Town of Hilton Head Island

Design Review Board Meeting

Tuesday, October 8, 2024, 2:30 PM

TWO PARK LANE | MULTI-TENANT MONUMENT SIGNS

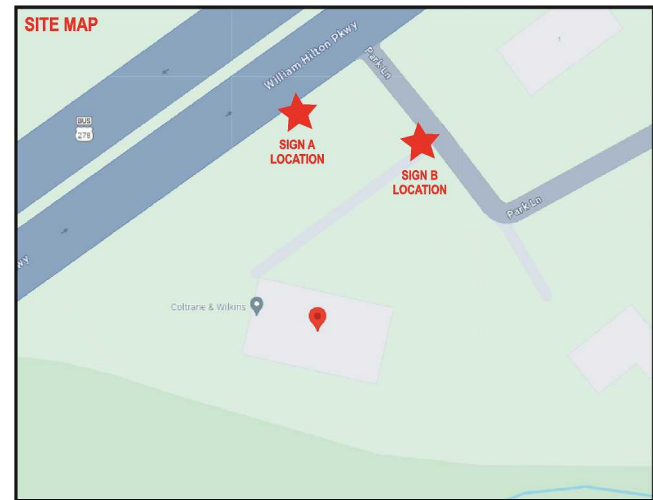
DRB REQUIREMENTS	Complies Yes	No	Not Applicable	Comments or Conditions
Demolition Plan if needed	☐	☐	☒	
Existing Conditions match As-Built	☐	☐	☒	Provide existing photos of the current signs.
Dimensioned Details and of Sections	☒	☐	☐	
Detail Illustrating Connection to Existing Structure	☐	☐	☒	
New Building Details Match Existing Building Details	☐	☐	☒

LANDSCAPE DESIGN				
DESIGN GUIDE/LMO CRITERIA	Complies Yes	No	Not Applicable	Comments or Conditions
Treats the Landscape as a major element of the project	☐	☒	☐	Provide existing and proposed landscaping around the signs.
Provides Landscaping of a scope and size that is in proportion to the scale of the development	☒	☐	☐	
Landscape is designed so that it may be maintained in its natural shape and size	☐	☒	☐	
Preserves a variety of existing native trees and shrubs	☐	☒	☐	
Provides for a harmonious setting for the site's structures, parking areas or other construction	☐	☐	☒	
Location of existing trees and new trees provides street buffers, mitigation for parking lots, and an architectural complement that visually mitigates between parking lots and building(s)	☐	☐	☒	
Shrubs are selected to complement the natural setting, provide visual interest and screen less-desirable elements of the project	☐	☒	☐

1. Staff recommends approval of the development submittal with the following conditions:
 - a. A sign permit for both monument signs will be required.
 - b. Provide existing photos of the current signs.
 - c. Provide existing and proposed landscaping around the signs.
 - d. Show any exterior lighting that will be used for the signs and landscaping.
2. Any additional information as required by the Board.

PAVILION
CONCEPT PLAN
& SECTION

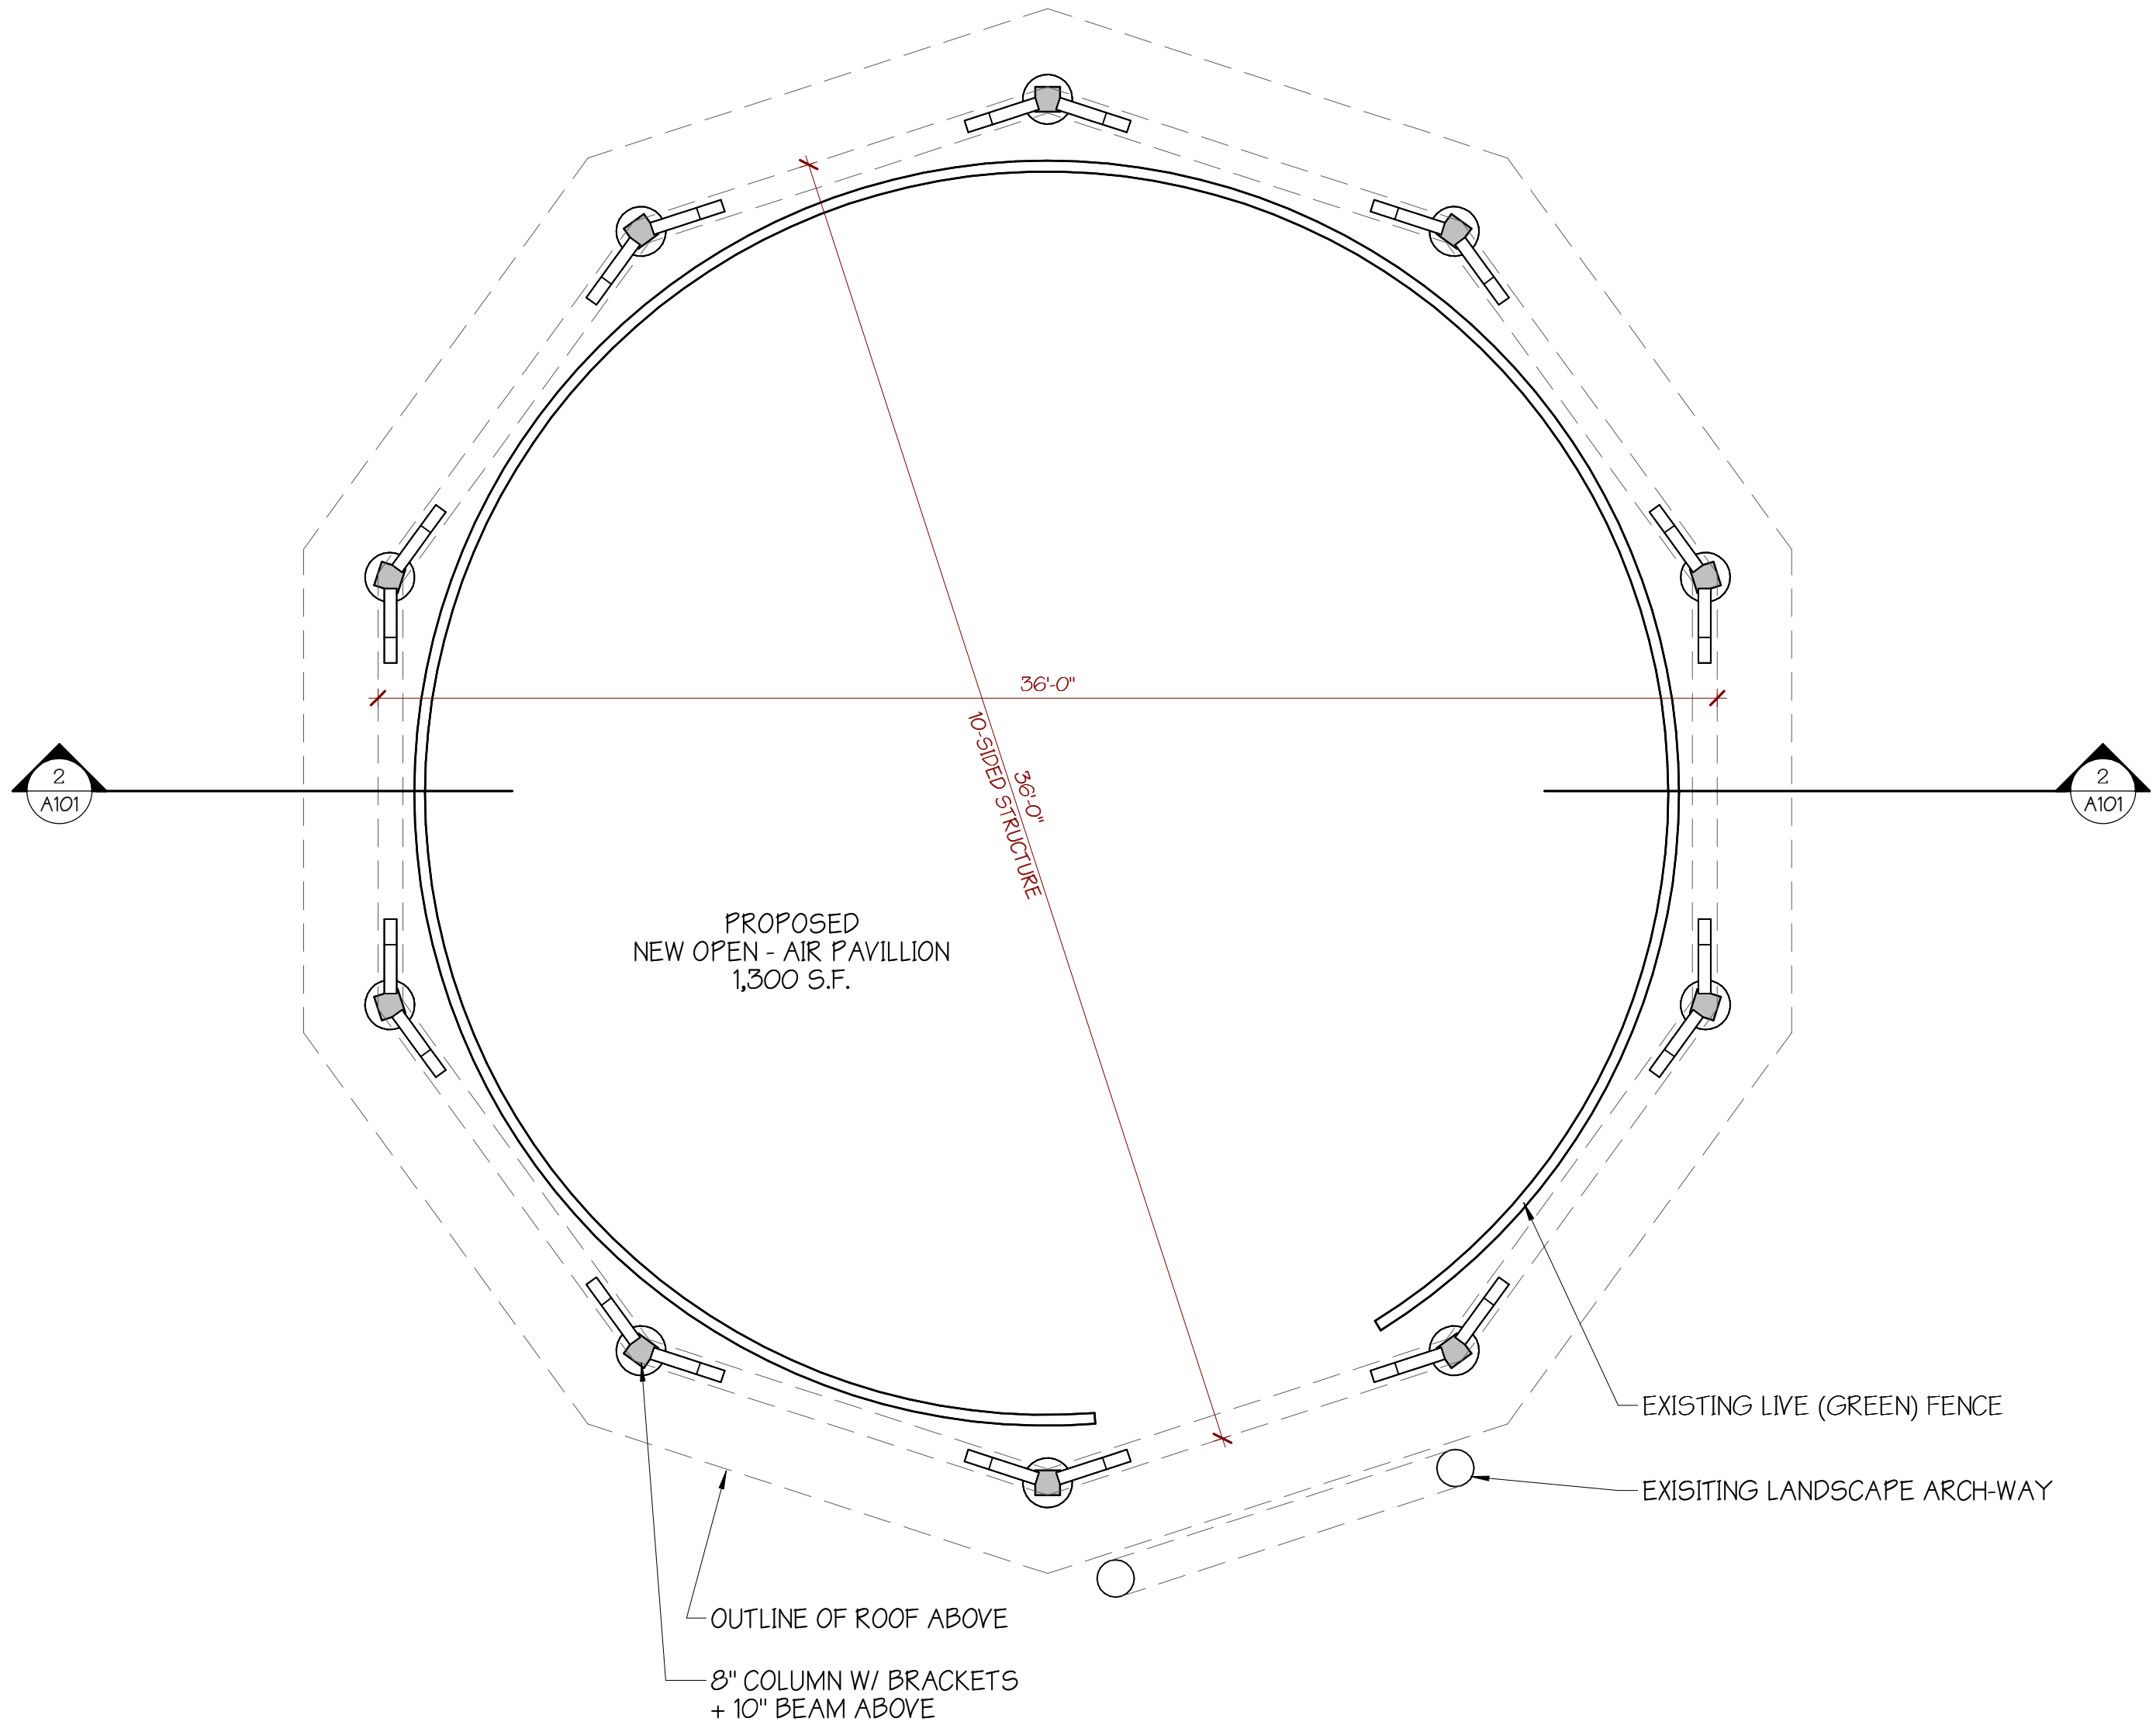
DRB REQUIREMENTS	Complies Yes	No	Not Applicable	Comments or Conditions
Demolition Plan if needed	☐	☐	☒	
Existing Conditions match As-Built	☐	☒	☐	
Dimensioned Details and of Sections	☒	☐	☐	
Detail Illustrating Connection to Existing Structure	☐	☒	☐	Provide elevations and renderings of the proposed design including the whiskey bar and the landscaping in the subject area.
New Building Details Match Existing Building Details	☐	☒	☐

1. Staff recommends approval of the conceptual design submittal with the following conditions:
 - a. Provide elevations and renderings of the proposed design including the whiskey bar, landscaping, hardscaping and site furnishings.
 - b. Provide an existing and proposed landscape plan.
 - c. Provide any screening for utilities on-site.
 - d. Provide a lighting plan.
 - e. Provide a 11” x 17” material and color board.
